ENGINE - LP COMPRESSOR - PROVIDE A NEW WEIGHT REDUCED FAN CASE ASSEMBLY - CATEGORY  
CODE 7 - MOD.ENG-72-0103

V2500-ENG-72-0103

1, Fan Exit Guide Vane (FEGV) A/O - Before and After Alteration  
Fig.8

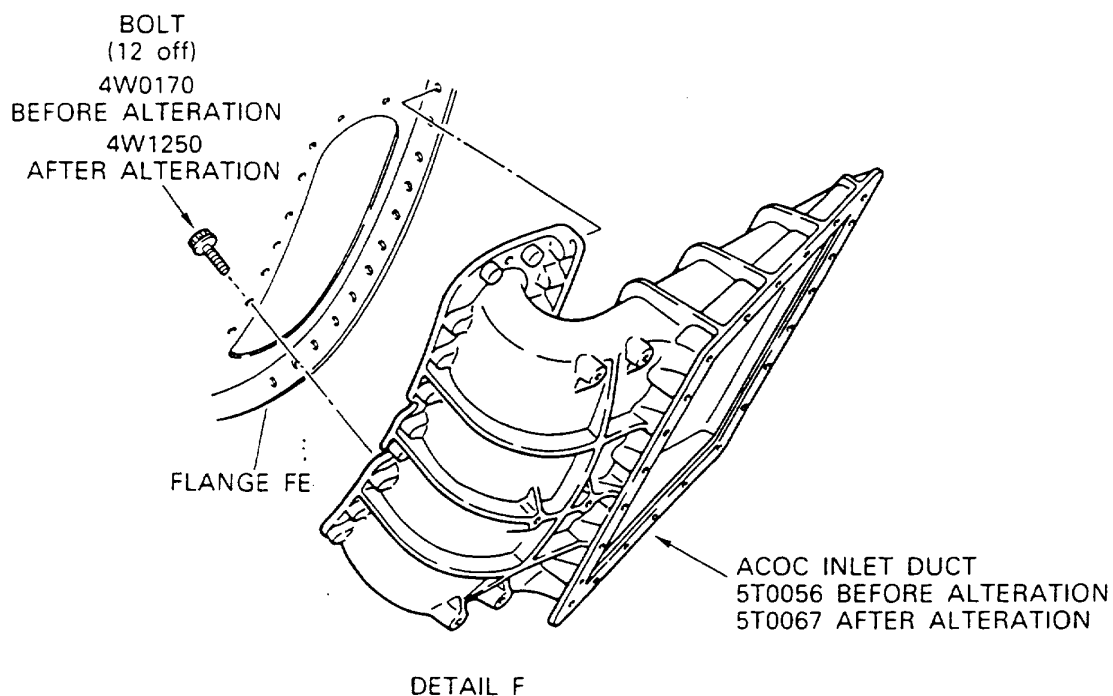
- (g) The profile of the Fan Exit Guide Vane inner and outer platforms has been changed from the parallelogram to the rectangle to enable the removal and installation of the FEGV's with the new configuration of Fan Case Assembly (See Figure 8).

- (4) Assemble the 20, 5A1364, FEGV's to the LP Compressor/Intermediate Case Module by use of approved procedures in the Engine Manual, 72-32-00, Assembly (Refer to Figure 8 and 1.K. (3)).

NOTE: The new FEGV's are not accessible if the Rear Fairing A/O's introduced by SB. No. V2500-ENG-72-0105 are installed. make sure that the Rear Fairing A/O's are not installed before the installation of FEGV's.

ACOC Inlet Duct - Before and After Alteration  
Fig.9

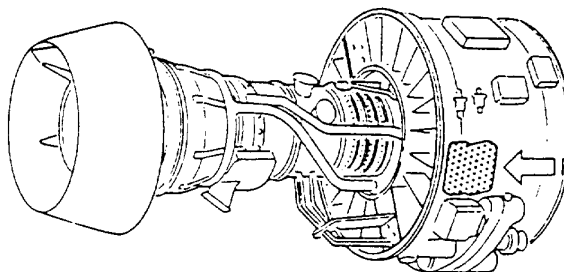
(h) The new Air Cooled Oil Cooler (ACOC) inlet duct has been introduced for this new configuration (See Figure 9).

- (5) Assemble the five 5R0174, Transition Panels to the 5W0124, Fan Case Assembly by the approved procedures in the Engine Manual, 72-32-00, Assembly (Refer to Figure 2 and 1.K. (3)).
- (6) Install the 5T0067, ACOC Inlet Duct and ACOC to the 5W0124, Fan Case Assembly by the approved procedures in the Engine Manual, 72-00-32, Installation (Refer to Figure 9 and 1.K. (3)).
- (7) Replace the Module Identification Plate in accordance with following procedures (Refer to Figure 10);

Reidentification of the new module identification plate  
Fig.10

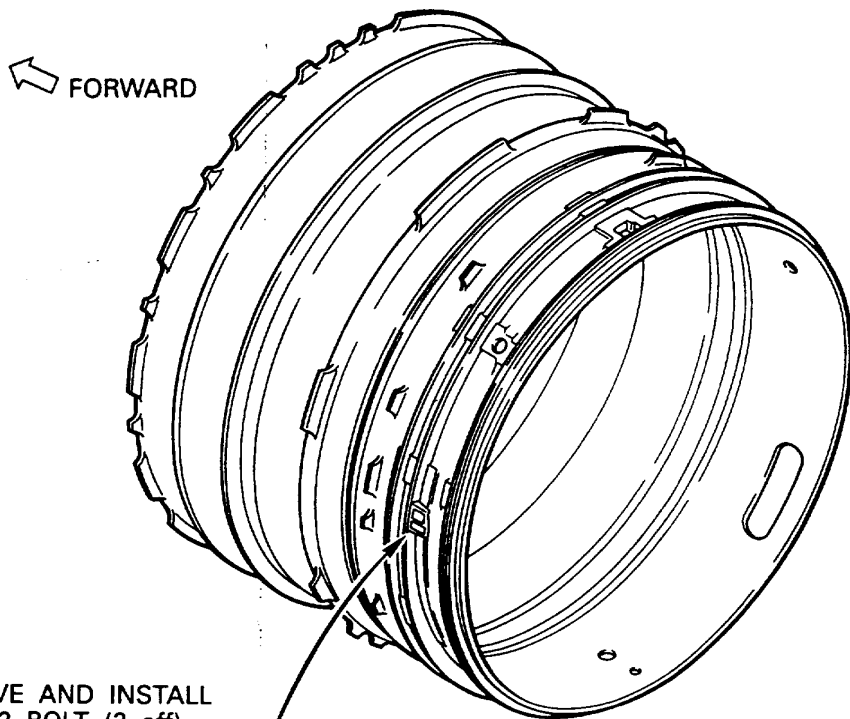
(2) The Module Assembly Number (Module Identification Number) marked on the LP Compressor/Intermediate Module has been changed.

REMOVE AND INSTALL  
4W0102 BOLT (2 off)

MAKE A MARK OF THE EXISTING SERIAL No.  
WITH METAL STAMPING

MAKE A MARK OF THE NEW PN 5W0127  
WITH METAL STAMPING

REMOVE AND DISCARD  
OLD IDENTIFICATION PLATE  
AND INSTALL NEW 5A2189  
IDENTIFICATION PLATE

- (a) Find the existing Module Identification Plate on the LP Compressor/Intermediate Module and make sure that Module Assembly Number is 5W0102.
- (b) Remove the existing 4W0102, two bolts from the module identification plate on the fan case.
- (c) Remove the existing module identification plate and discard it.

- (d) Make a mark of the new module assembly number 5W0127, and existing serial number to the new 5A2189, module identification plate by the approved procedures in Reference (4), Chapter/Section 70-09-00, Marking of Parts.
- (e) Install the marked new module identification plate with the two 4W0102, bolts in to sufficient position.
- (f) Torque the bolts to 36 to 45 lbfin (4,00 to 5,00 Nm) with CoMat 10-077 approved engine oil.
